The British Horse Society
Abbey Park
Stareton
Kenilworth
Warwickshire CV8 2XZ

Re: Development 25/02571/OP – Baldock

Planning Statement

Green Infrastructure Strategy

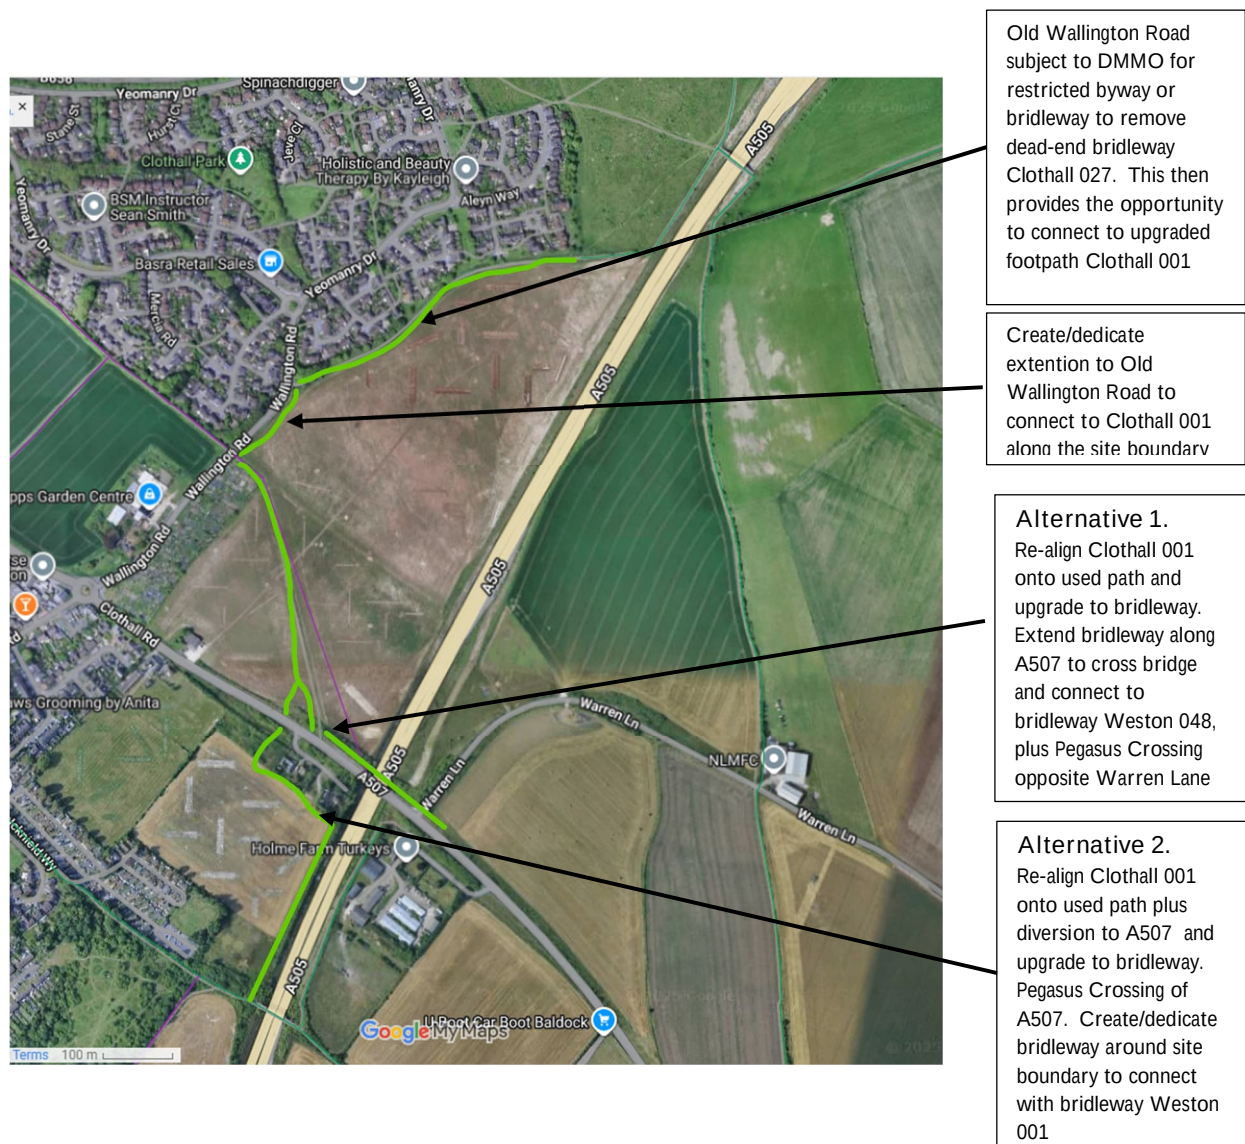
It is noted that a figure of a horse rider appears twice in Figure 10 Green Infrastructure Influences, but other routes equestrian are outlined in these plans. These should be made clear in later sections.
